UNIVERSITY OF MARYLAND

Enclosed please find the University of Maryland's response to the request for additional information as it pertains to sections six through ten of the Safety Analysis Report (SAR).

REQUEST FOR ADDITIONAL INFORMATION
UNIVERSITY OF MARYLAND RESEARCH REACTOR
DOCKET NO. 50-166

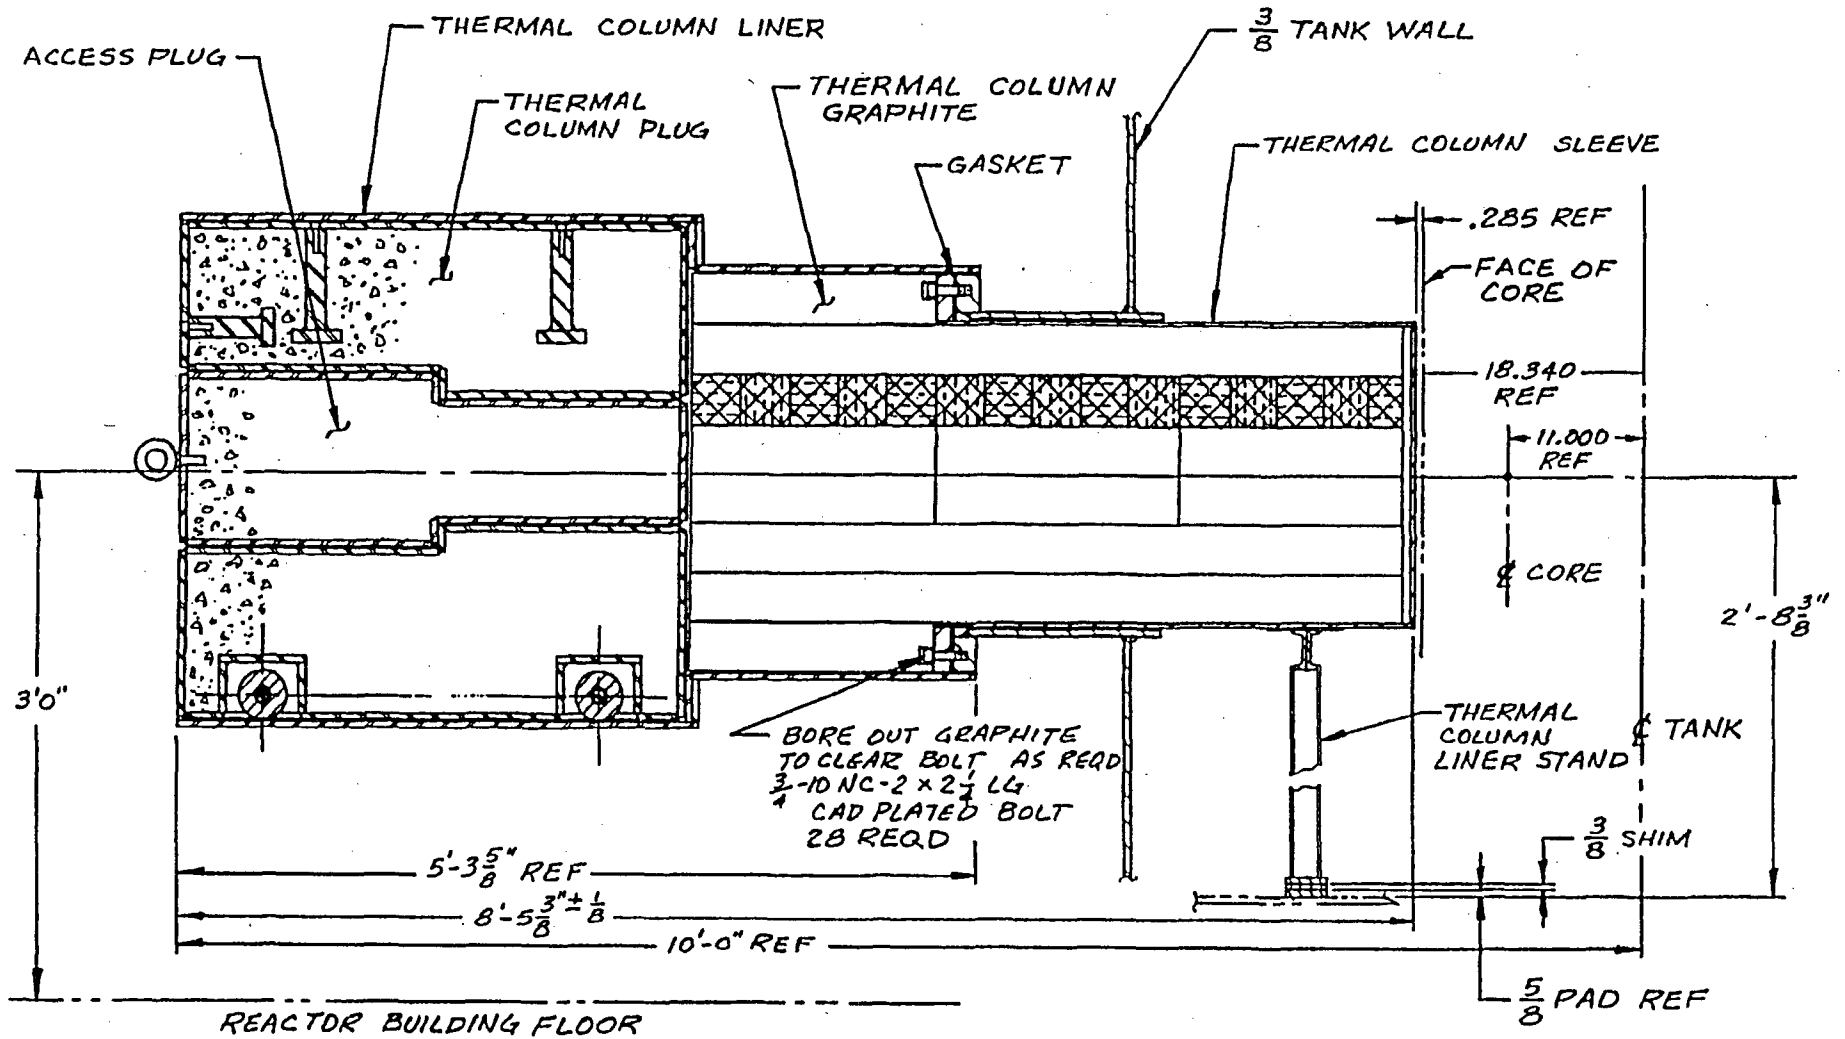
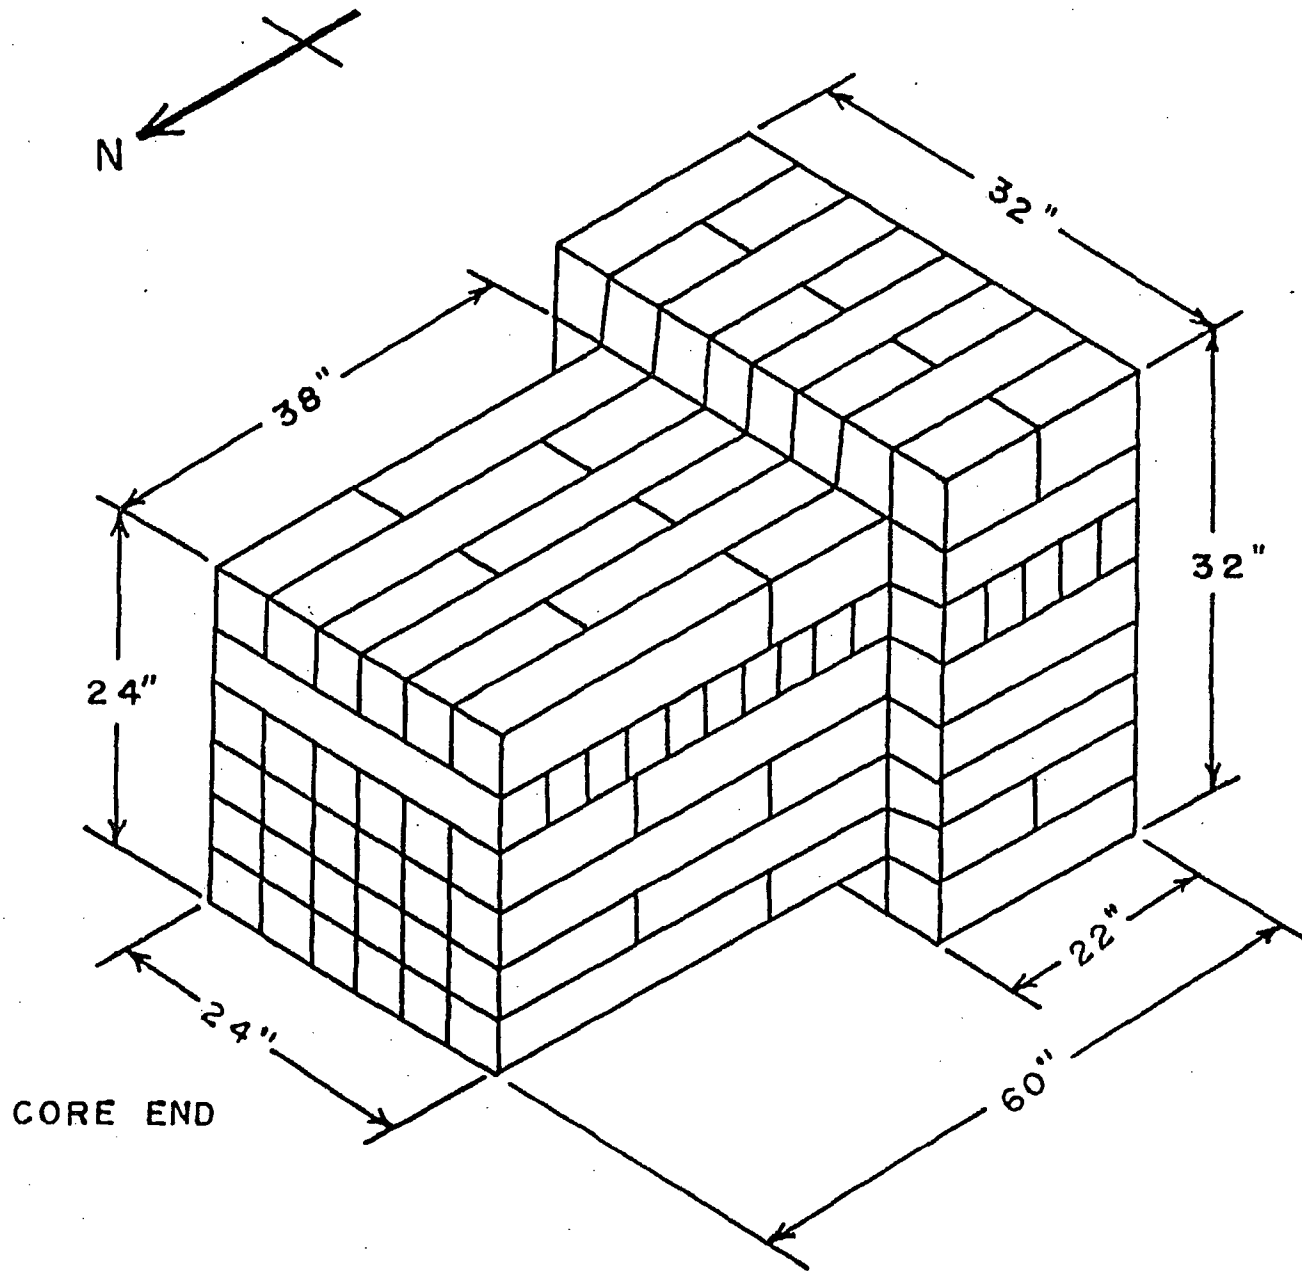
38. Section 10.2, Experimental Facilities. Provide a more detailed description of the functional design of the Thermal Column, Beam Ports and Through Tube experimental facilities. For example, from the description provided it is not clear if these facilities require an air exhaust system or if beam tubes must be filled with demineralized water to provide shielding. Additionally, Figures 10.3, "Beam Tube," 10.4, "Beam Tube Plugs," and 10.5, "Through Tube" are not legible (apparently due to their reduced size). Please provide clearer illustrations that are of a larger size. Enlarging each figure to 8½ by 11 inches should be sufficient.

See Attached
